**Response to Data Requests
16 and 55 through 72**

Petition for Amendment No. 1

Russell City Energy Center

California Energy Commission

FIGURE DR55-1
HAYWARD EXECUTIVE AIRPORT
LAND USE SAFETY ZONES
RCEC AMENDMENT #1
HAYWARD, CALIFORNIA

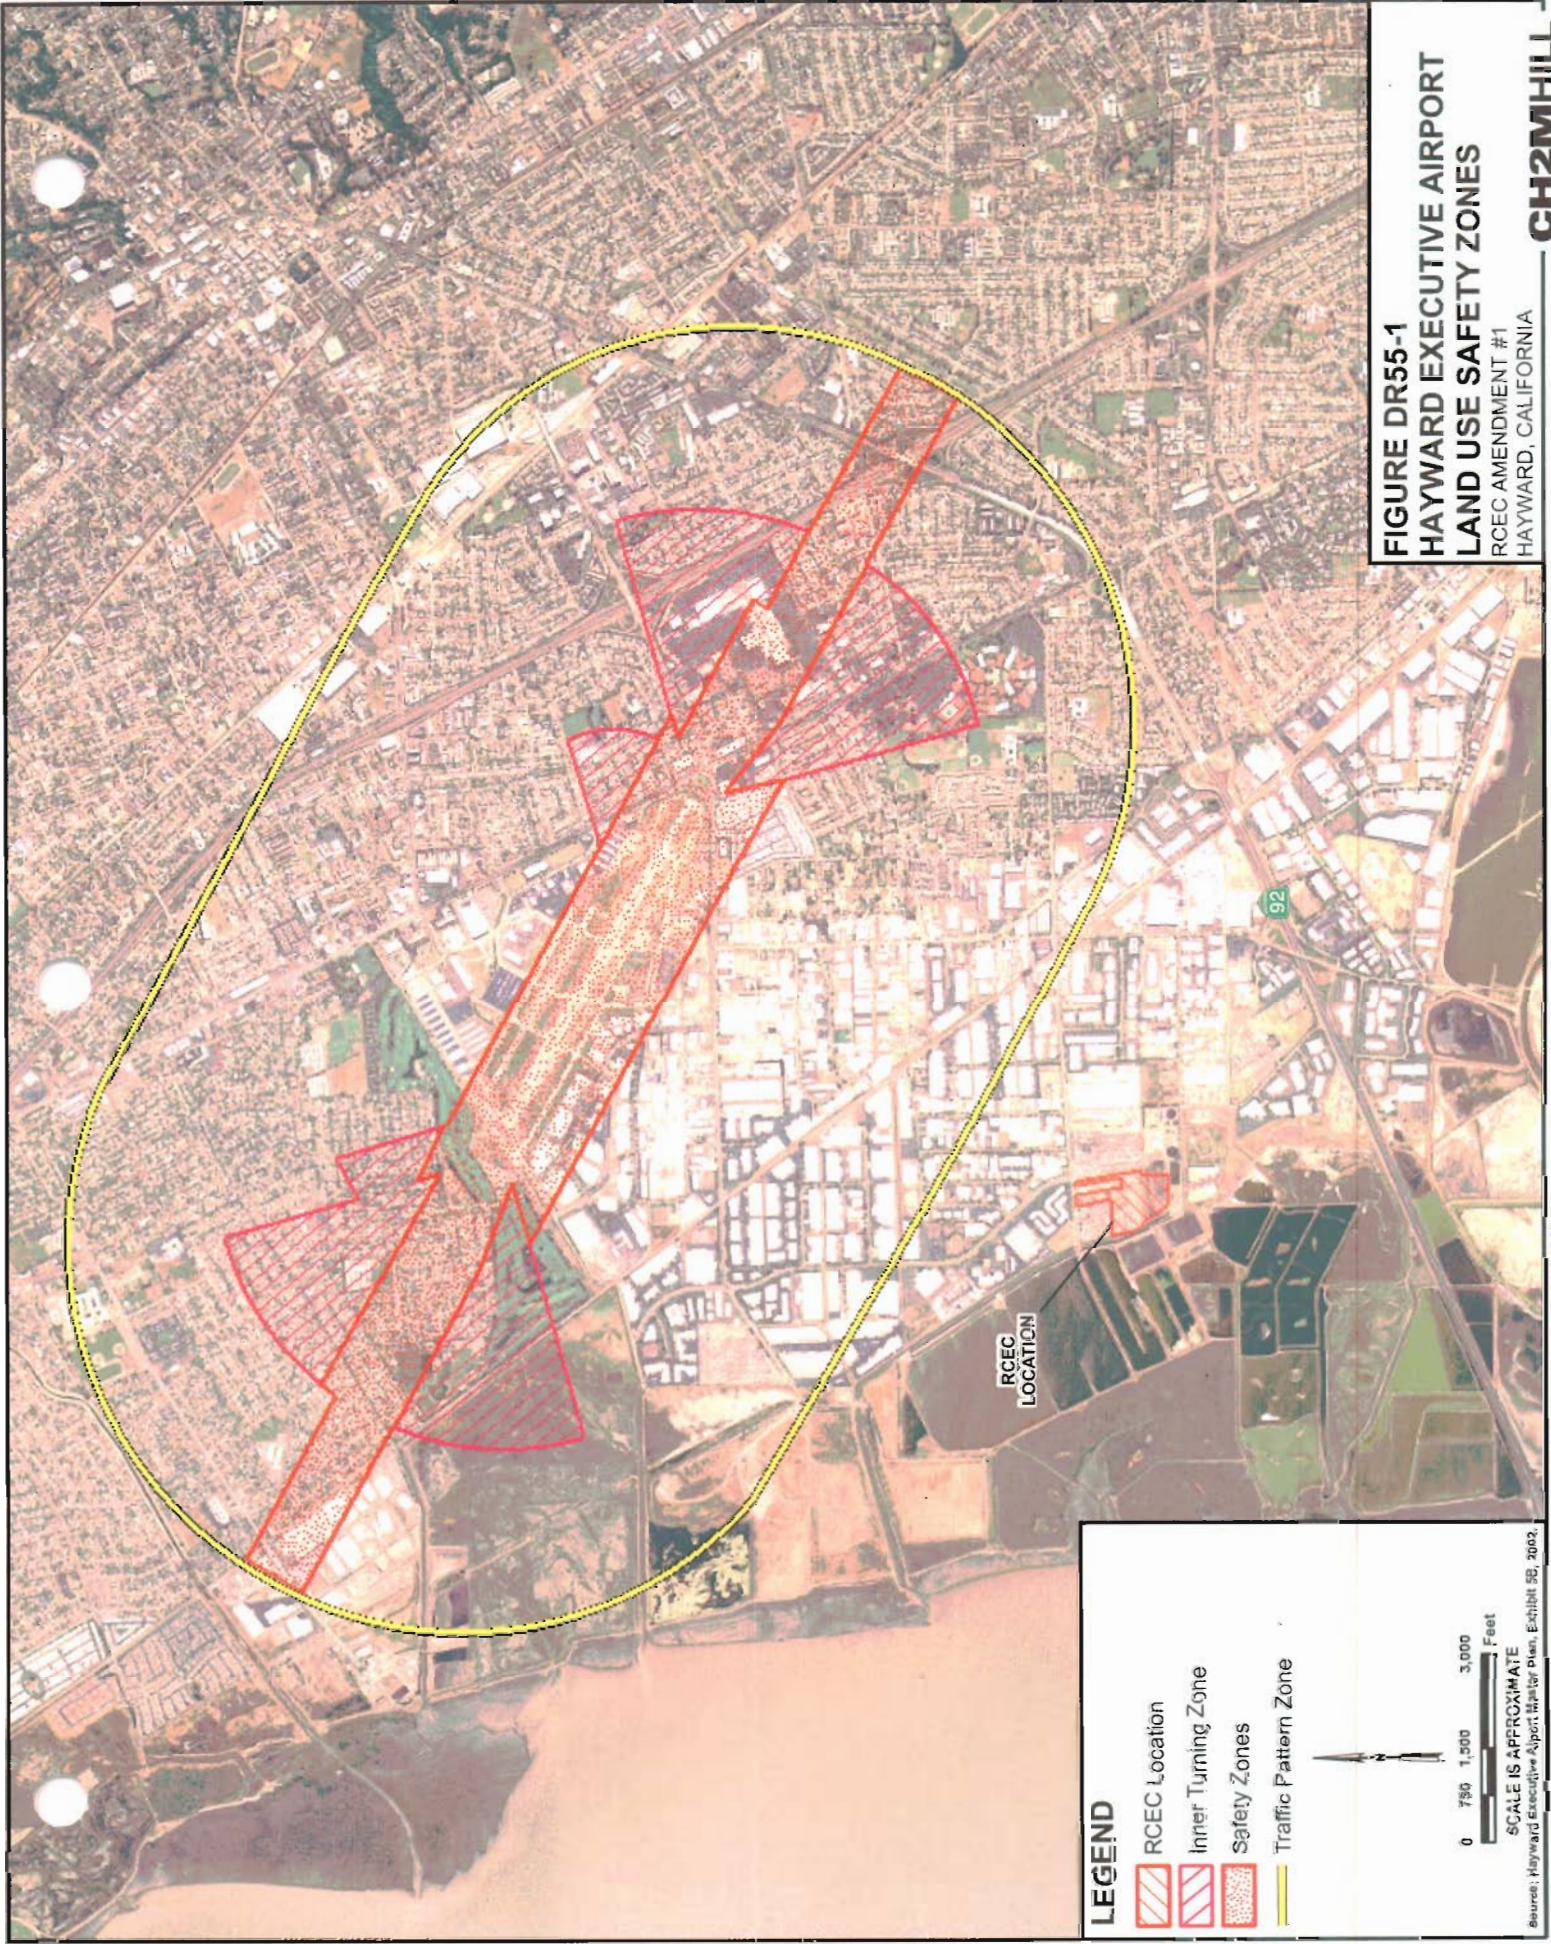
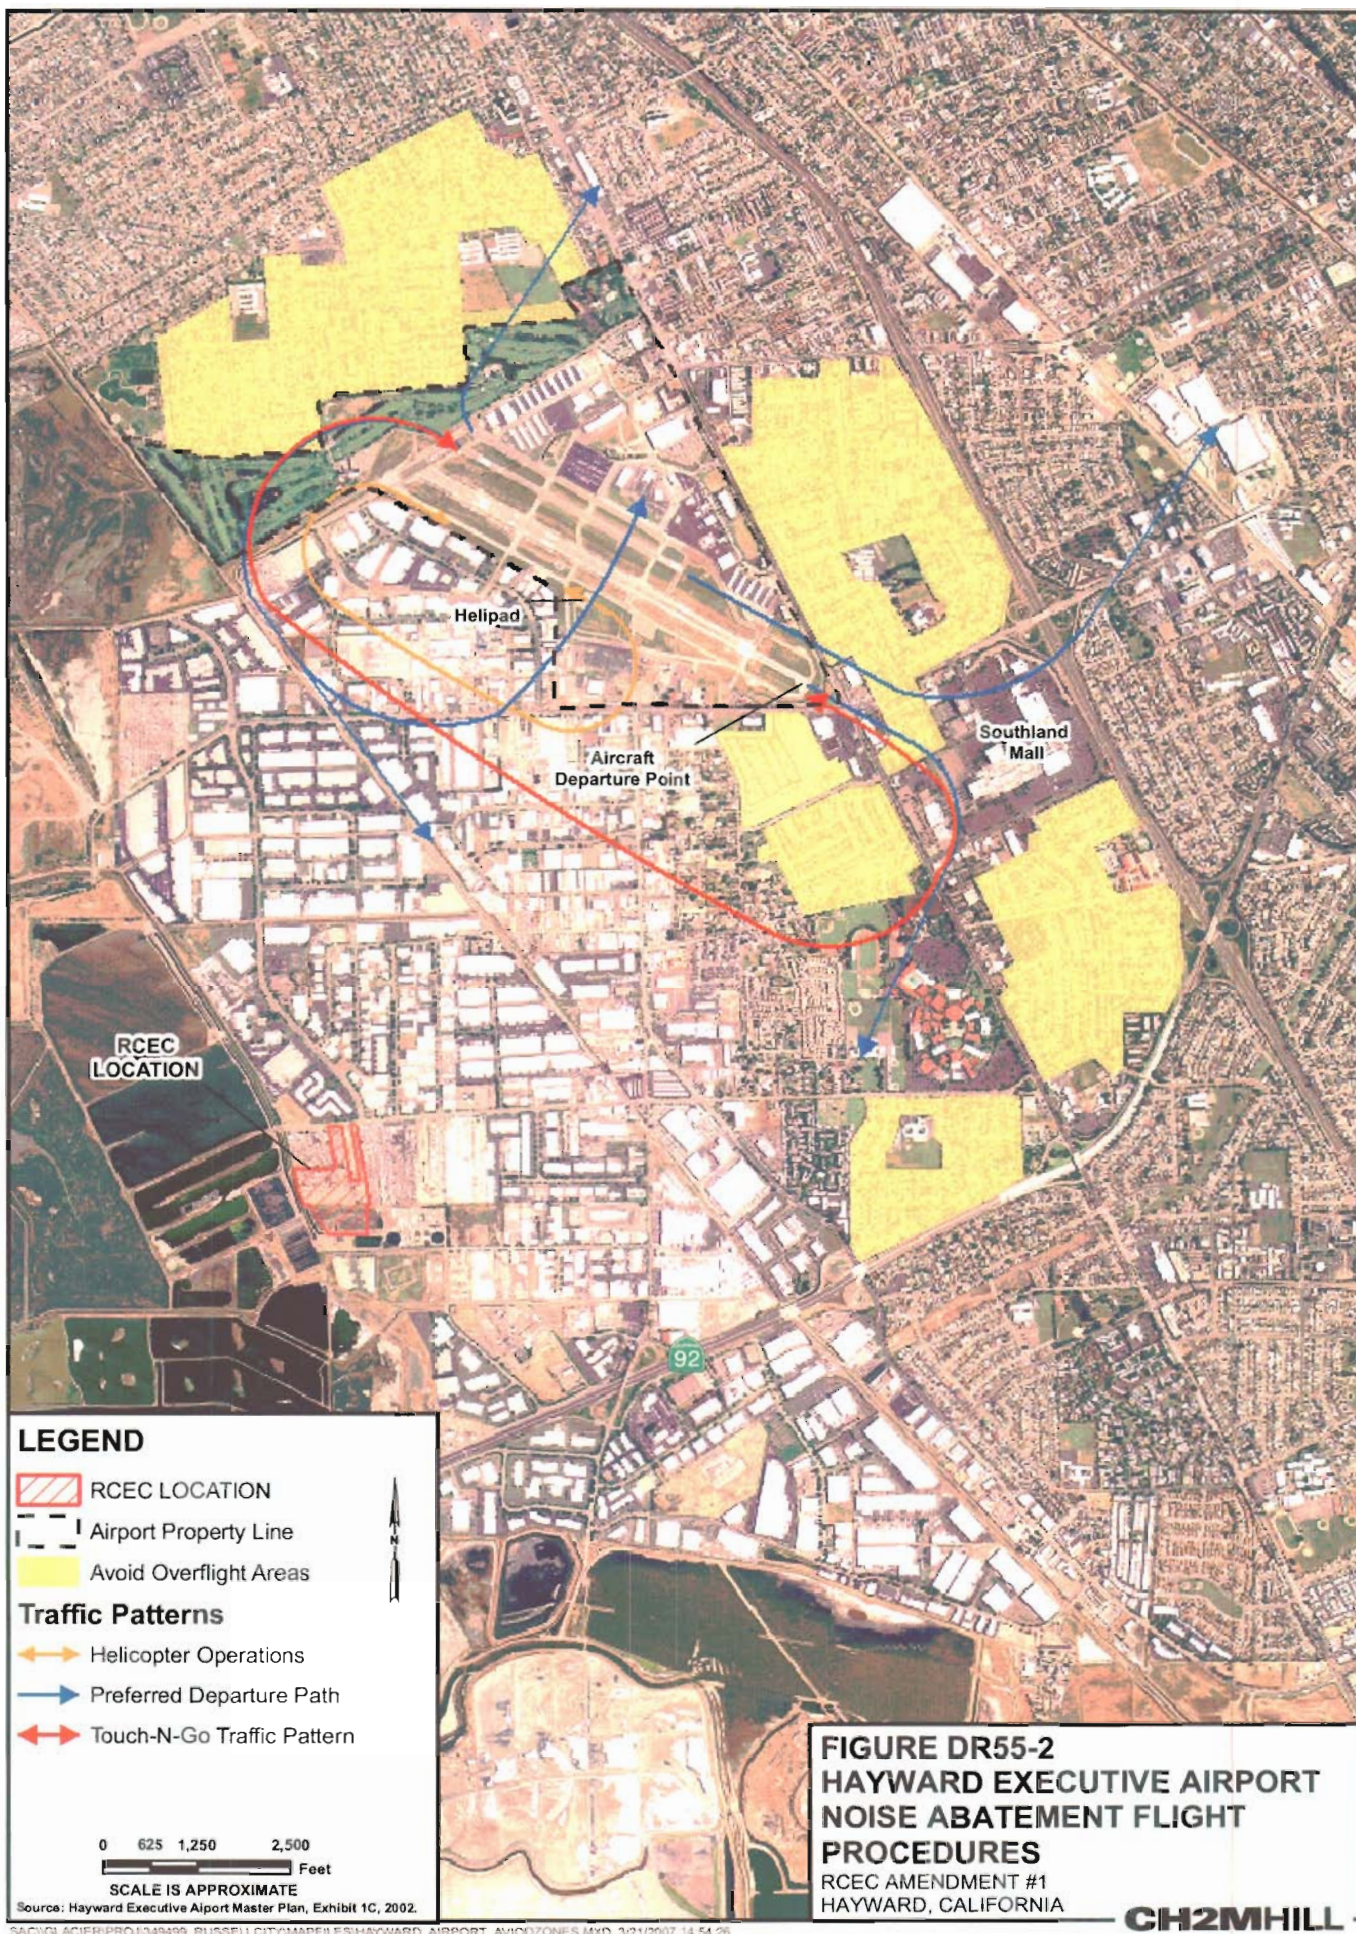
55. Please compare the currently proposed site to Alternative Site E with regard to aviation safety and consistency with the Hayward Airport Approach Zoning Plan (HMC §10-6.35).

Response: The proposed RCEC site would not cause a hazard to air navigation and would not "endanger the landing, take-off, or maneuvering of aircraft." The RCEC is located more than 1.5 miles from the nearest point of the nearest runway and is not located along or underneath any of the recognized approach patterns for airport landing or takeoff. The proposed RCEC structures also would not penetrate any of the Federal Aviation Administration's (FAA's) "imaginary surfaces" that define the protected airspace near a public airport, including the approach surface, transitional surface, or horizontal surface.

The City of Hayward's Airport Master Plan for Hayward Executive Airport (City of Hayward 2002) defines the airport's Traffic Pattern Zone, which extends about one mile from the airport runways and is the zone within which aircraft fly when circling the airport (See Hayward Executive Airport Master Plan, Exhibit 5B, Figure DR55-1). RCEC is outside of and about one half-mile southwest of this boundary.

The Hayward Airport Master Plan also mandates certain flight pathways for aircraft to follow for residential zone noise abatement. Aircraft taking off from the airport must follow certain clearly defined patterns to avoid flying over residential areas at low altitude. Neither the Preferred Departure Paths, Touch-n-go Traffic Pattern, or Helicopter Operations paths fly over the RCEC site or come any nearer than one half-mile from the RCEC site (Hayward Executive Airport Master Plan, Exhibit 1C, Figure DR55-2). In addition, the Pattern Altitude (the altitude at which aircraft are required to fly when circling the runway for landing approach) is 600 feet for Runway 28L-10R and 800 feet for Runway 28R-10L. The tallest RCEC structure (HRSG stacks) would be 145 feet high.

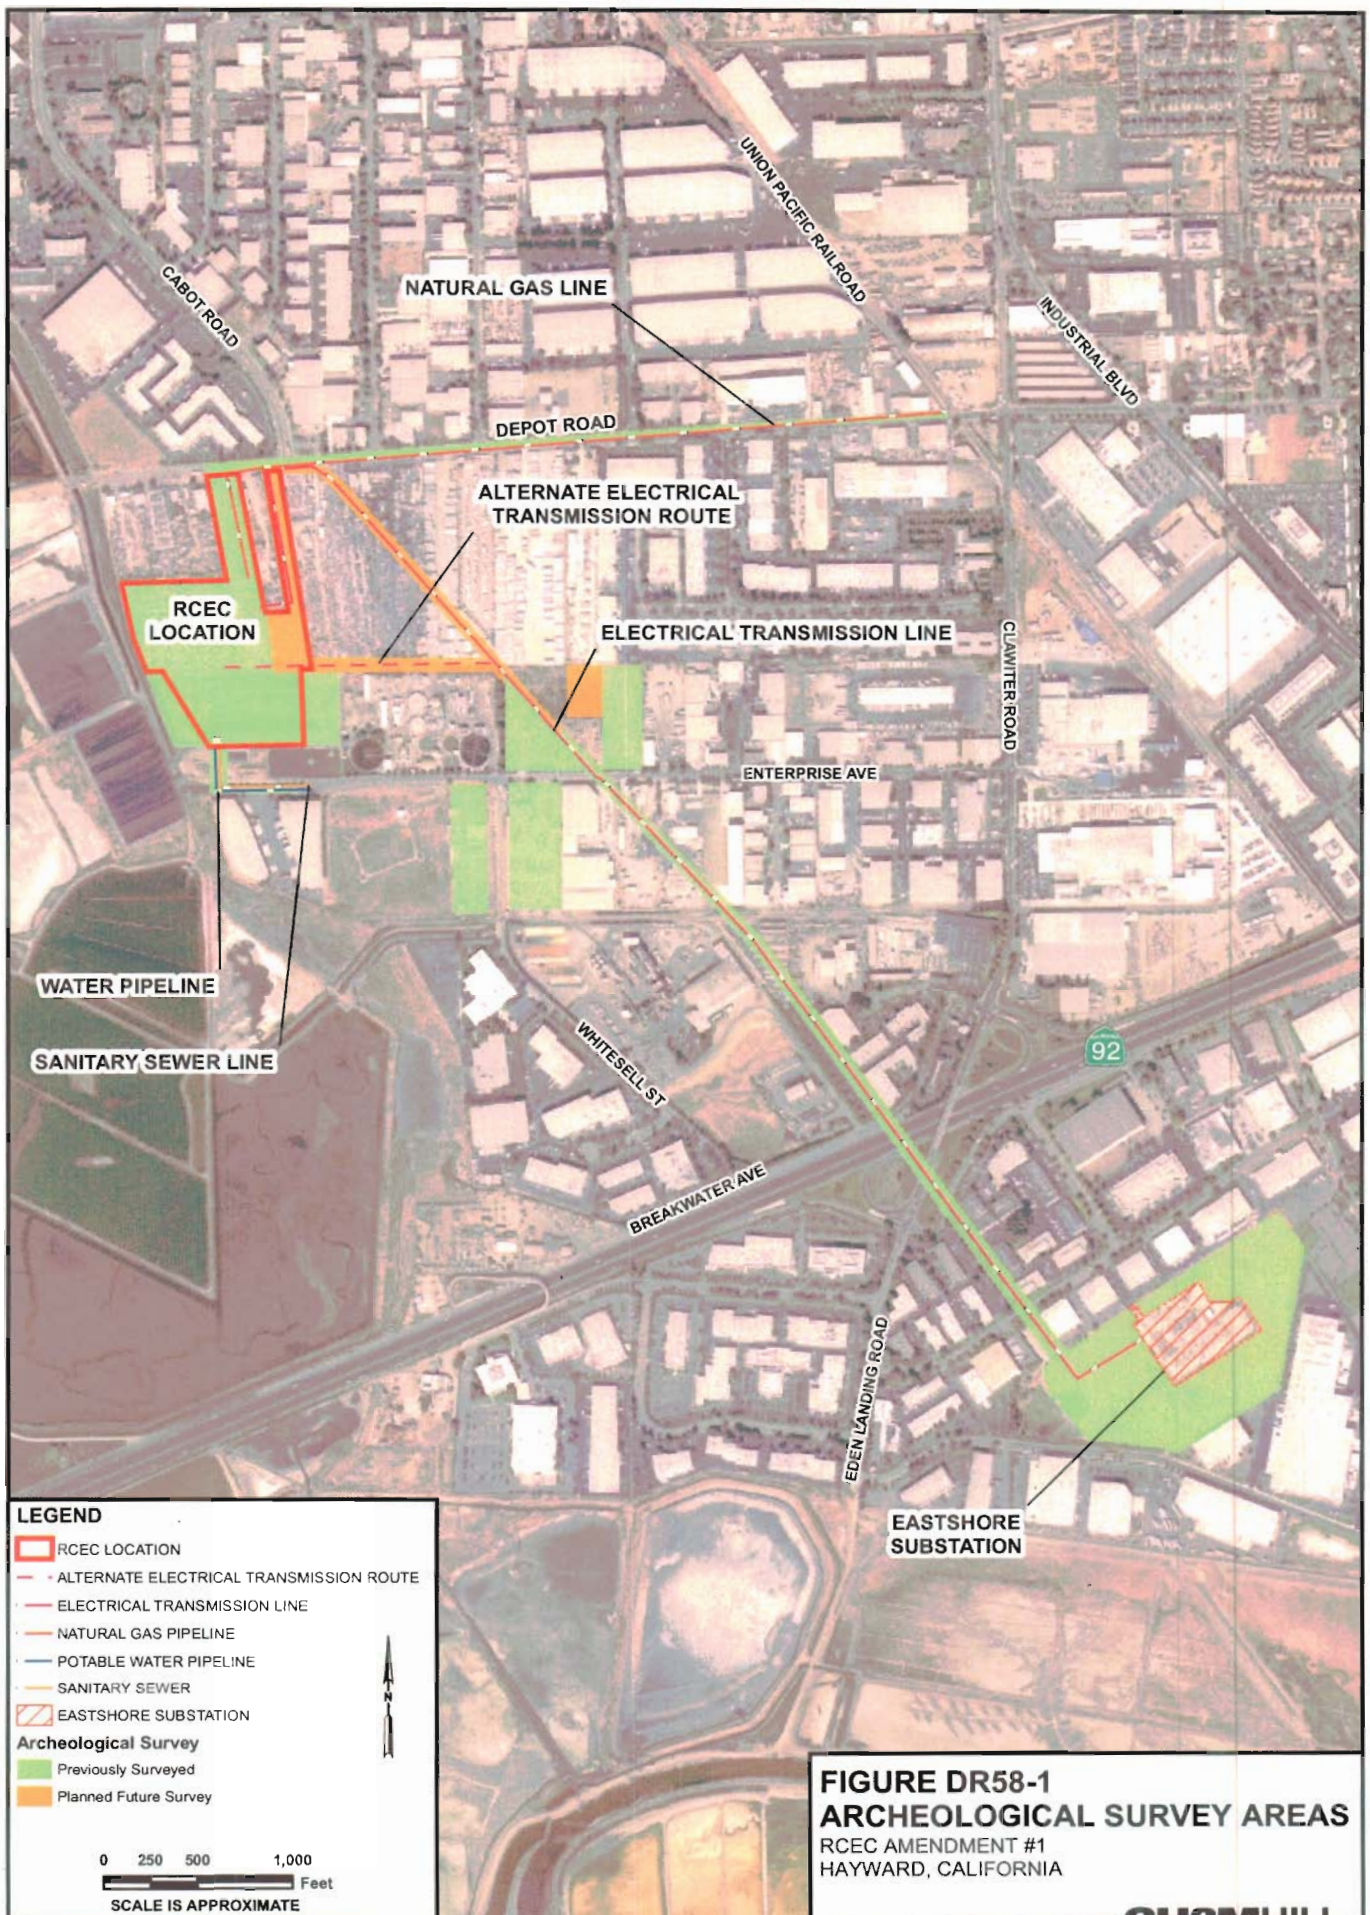
58. *Please identify areas on a revised Figure DR21-1 where access cannot be obtained or the ground is not visible, and provide a discussion of the steps taken to obtain access or a plan for conducting an archaeological survey at a later date when the ground is visible. If access cannot be obtained or the ground is not visible, please explain how the project proposes to conduct necessary archaeological surveys.*

Response: Figure DR58-1 shows areas for which site access is currently not available or the ground surface is not visible due to gravel fill and the presence of salvage automobiles, cargo containers, or other objects that prevent the surveyor from viewing the ground surface. Applicant proposes that these areas be surveyed during the construction preparation phase when these areas are accessible and when there is a greater chance of surveyors seeing the original ground surface without it being obscured by automobiles or other objects.
